preTDR Draft Review Process

Updates from the Lumi System

preTDR Draft Review Process - Lumi Systems

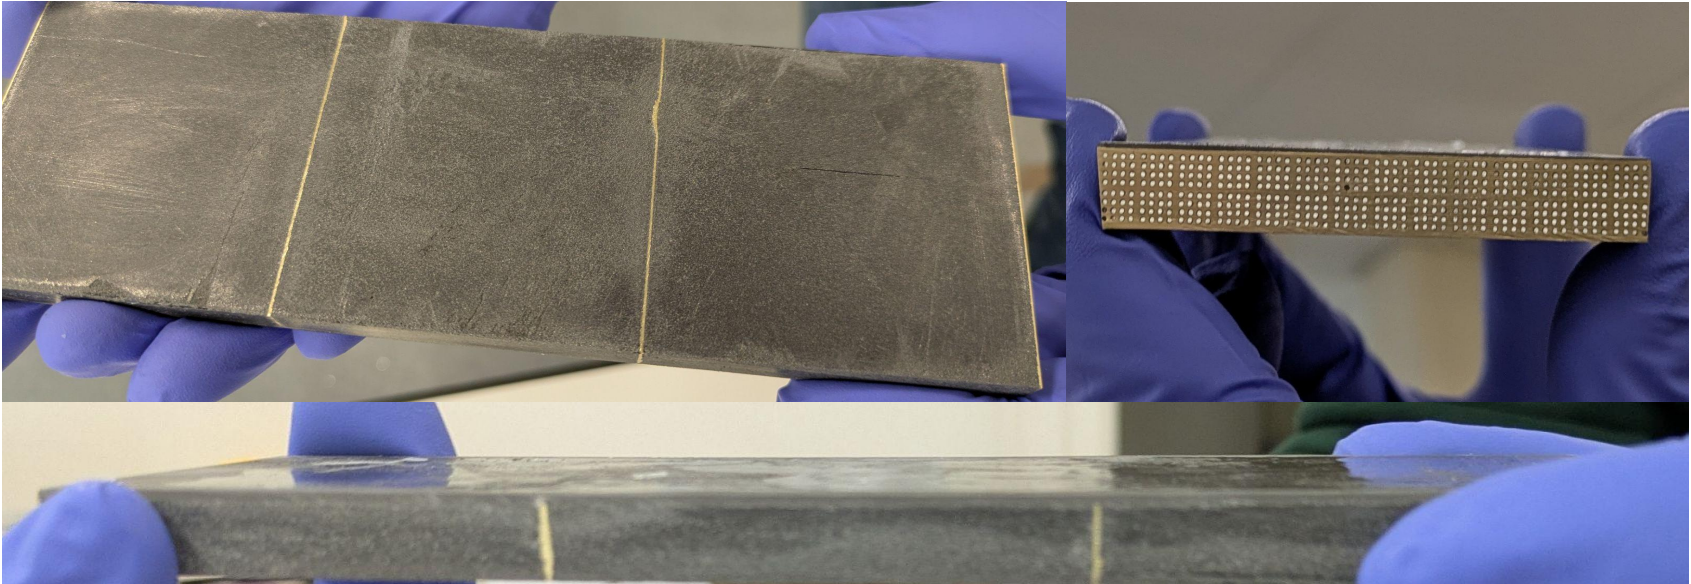
The readout scheme, requirements, and implementation are entirely missing from the current version, including details on monitoring and calibration schemes.

Will add further details on this, particularly given that readout is actively being prototyped.
